PCN No.:	AAB170013	Date:	18.06.2018
Product:	ST

## Change to O-ring of cable clamp type cage

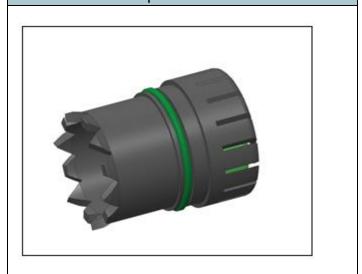
As part of the ongoing product improvement process, the color of the O-ring in the cable clamp type cage is being changed from black to green on selected products of the ST series.

The additional PTFE coating simultaneously makes assembly easier. This modification has no effect on tightness and the electrical properties of the connector.
